Title: Valor on Washington

Re: Urban Design Commission Application - Final  
Valor on Washington: 1322 East Washington Avenue

Enclosed are updated plans for the project known as Valor on Washington. In response to feedback at the June 12, 2019 UDC meeting, we have made the following adjustments:

Sheet No.  
A203

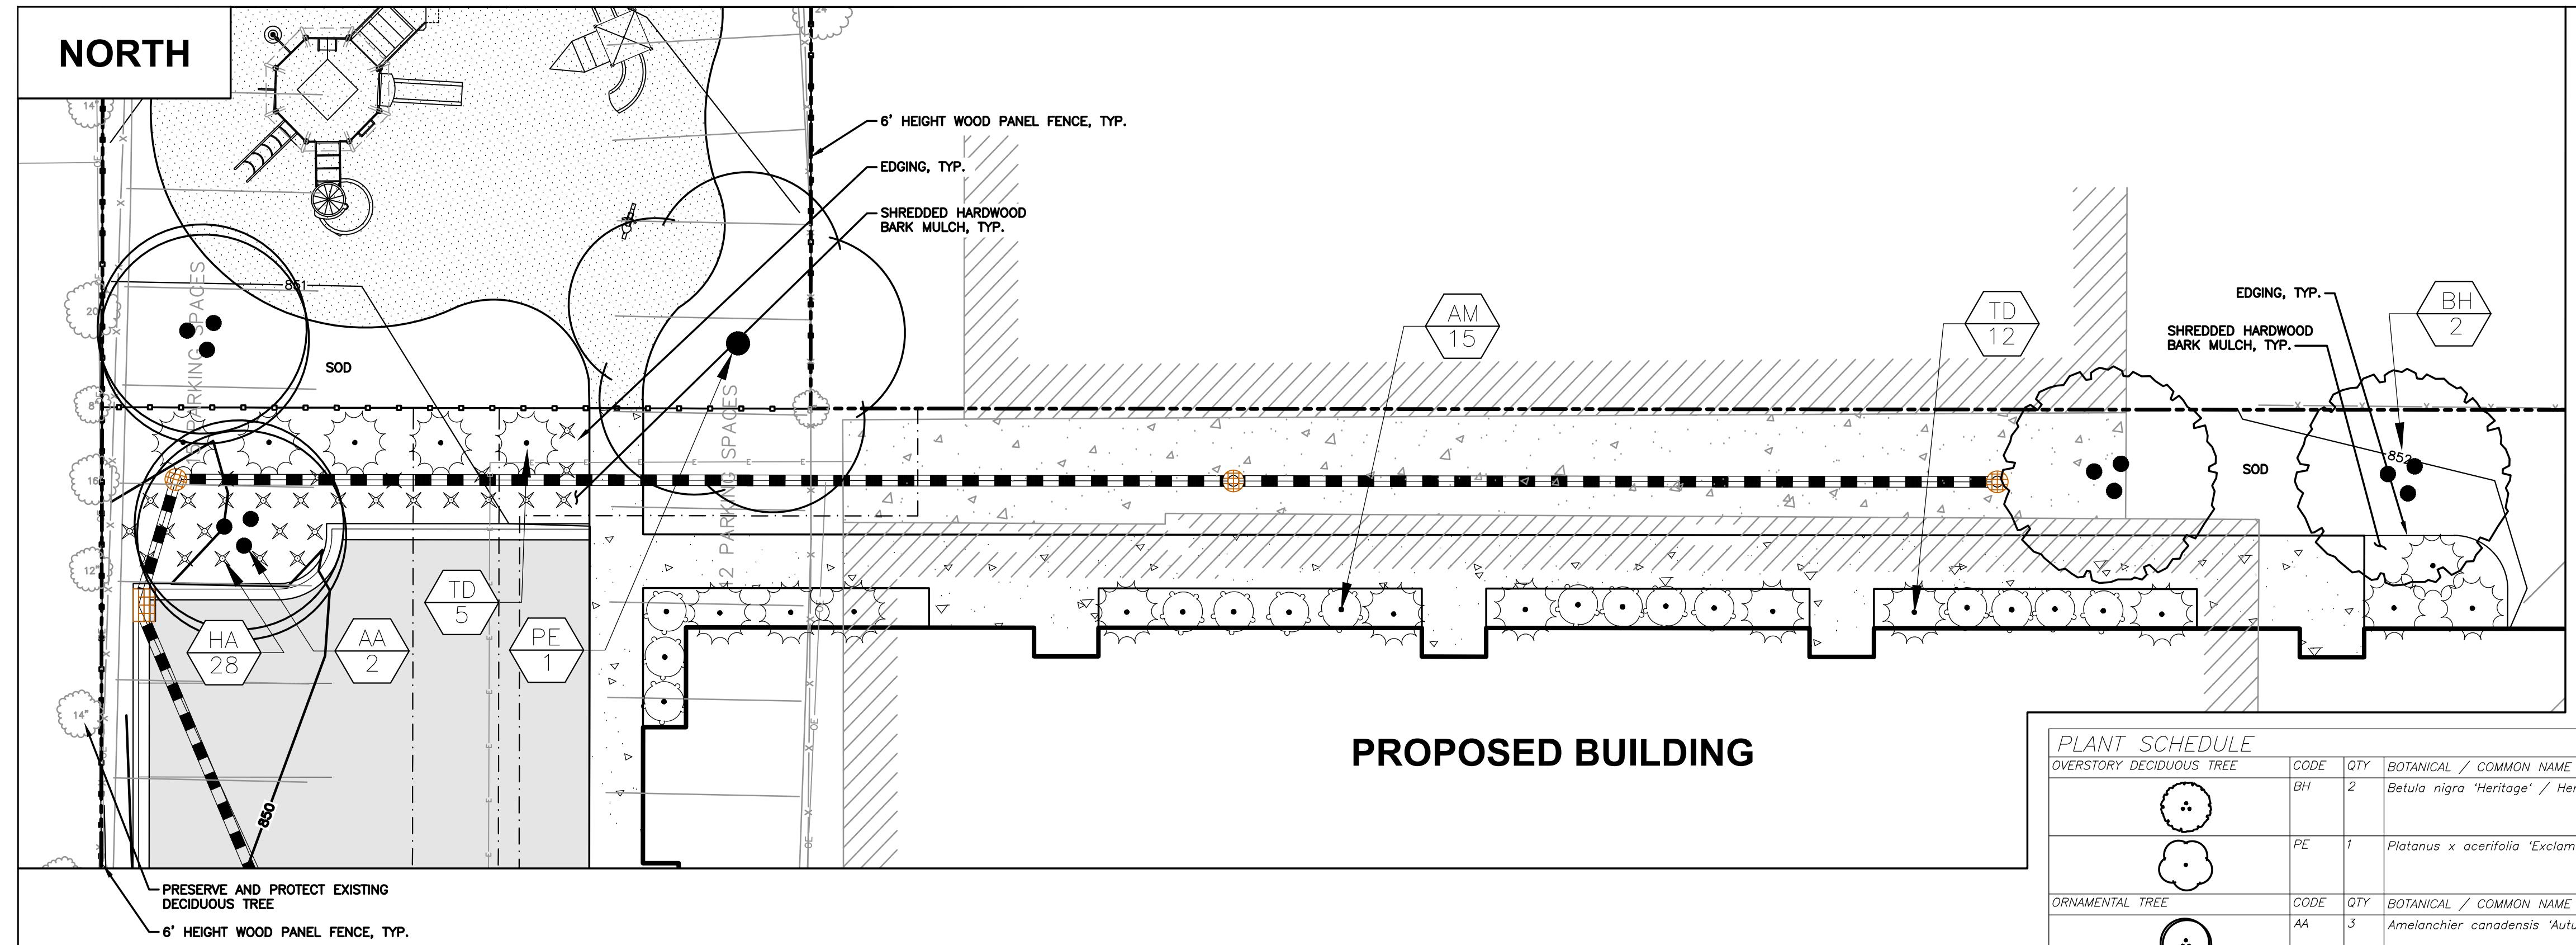
- *Metal panel gauge and installation method:* This detail shall be provided at June 26<sup>th</sup> meeting.
- *Elevation drawing views of all interior facades:* Elevation views for the north-facing lower roof building elevations are enclosed. Please refer to sheet A203.

- *Consider simplifying the material palette:* The elevations enclosed represent the following simplifications to the building elevations and materials. 1) At the request of the commission, brick has been removed from the north-facing lower roof building elevations. 2) The townhome facades material configurations have been modified/simplified. 3) the north-west building corner has been modified/simplified. Specifically, the lap siding inset has been changed to metal panel.

SHEET NUMBER:  
**L1.1**

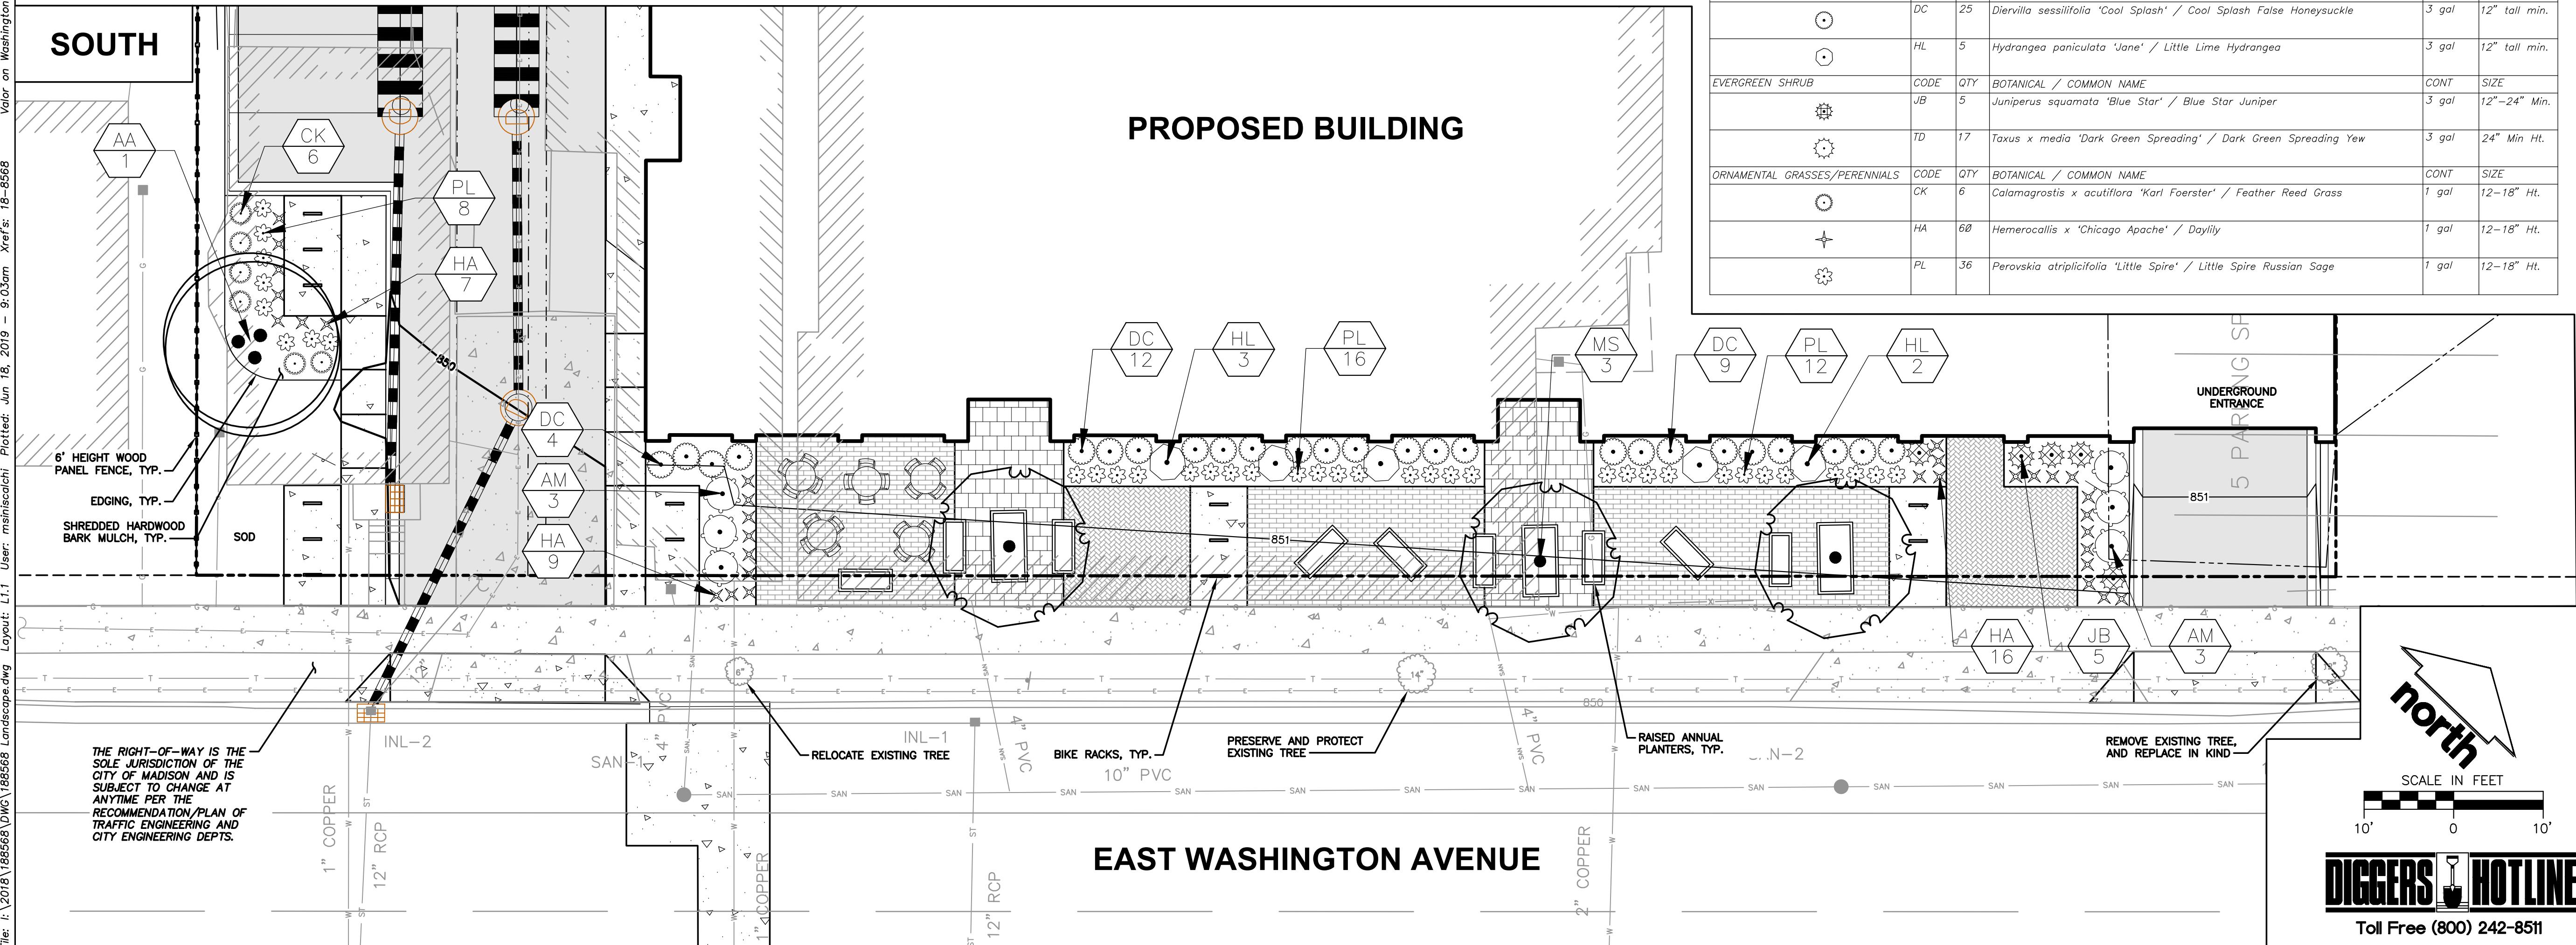
- (3) Cleveland Select Pear ornamental trees in front terrace have been removed and replaced with 'Spring Snow' Crabapple species
- 4x8 tree grates added for ornamental trees in front terrace
- Playground Area - (1) rear ornamental tree replaced by larger canopy shade tree on south east corner of playground

A Sheet Title  
ROOF PLAN - OVERALL

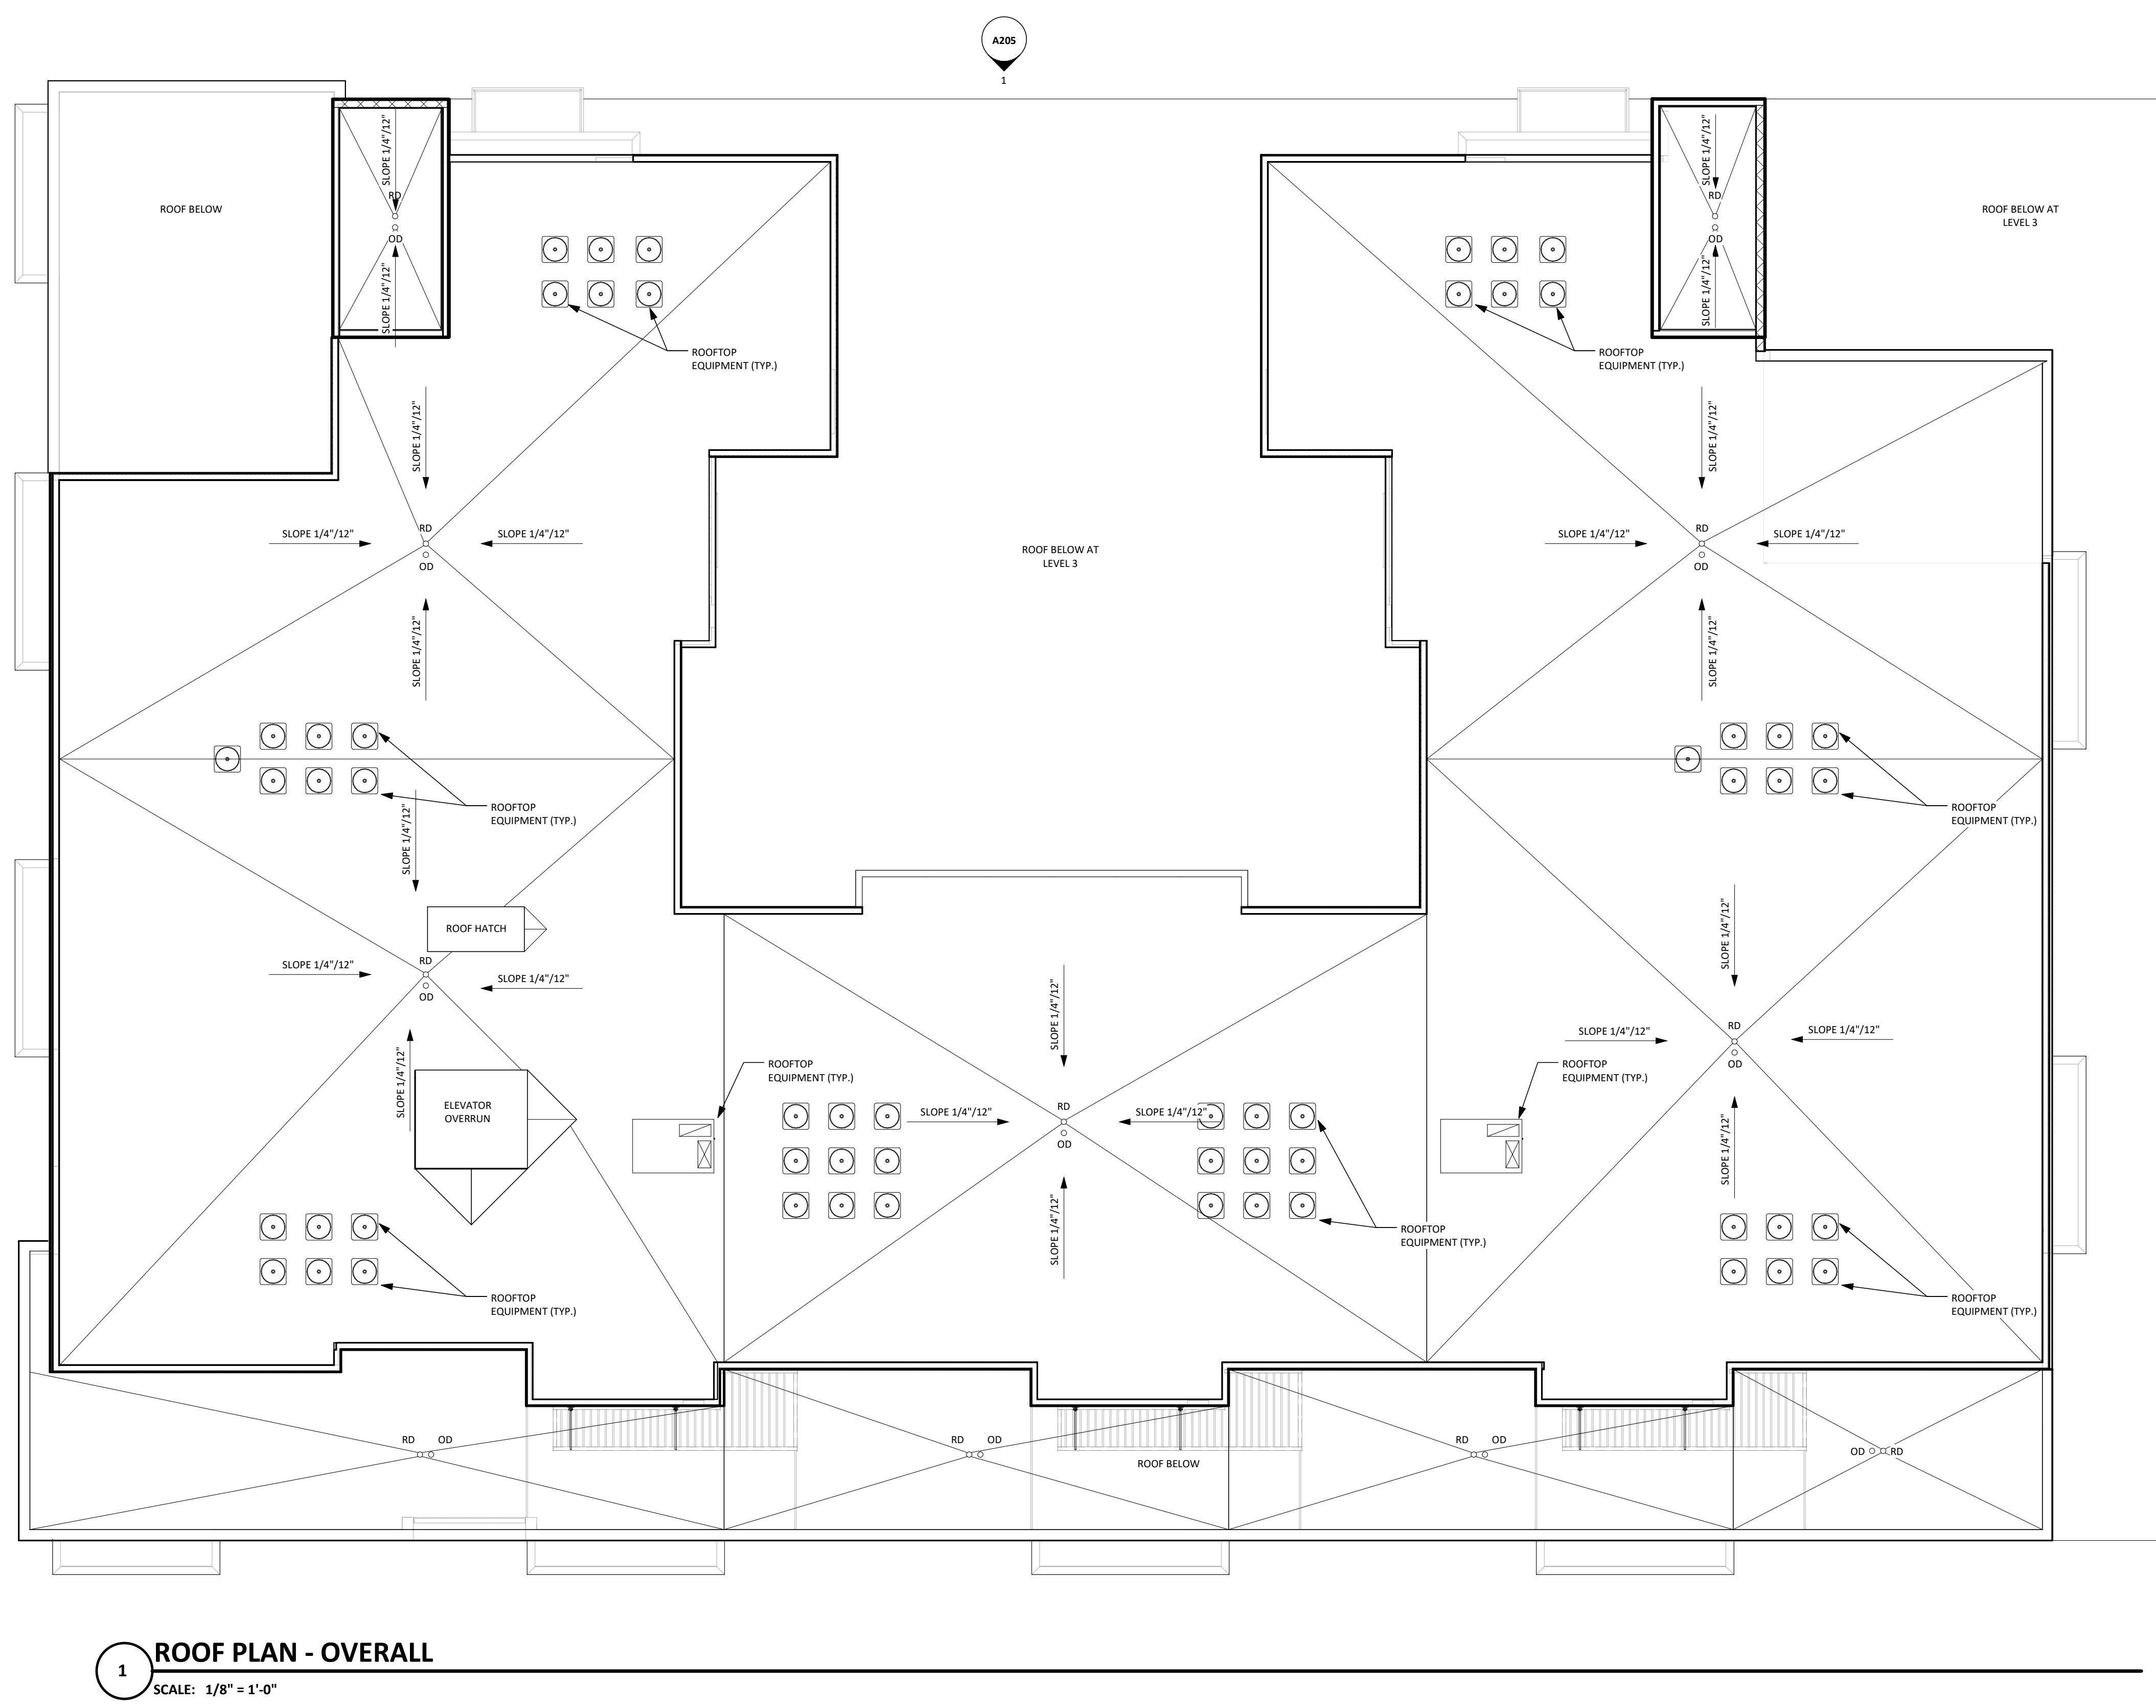
- *Provide more information on roof plan, including any landscaped areas and rooftop mounted mechanical equipment:* Roof plans for the lower and upper roofs are enclosed. There are no rooftop condensing units on the lower roof at level 3. Rooftop condensing units for the residential units, are showed at the upper roof plan. Additionally, (2) RTU's are shown on the upper roof plan, (1) for the commercial suite and (1) for resident amenity areas.
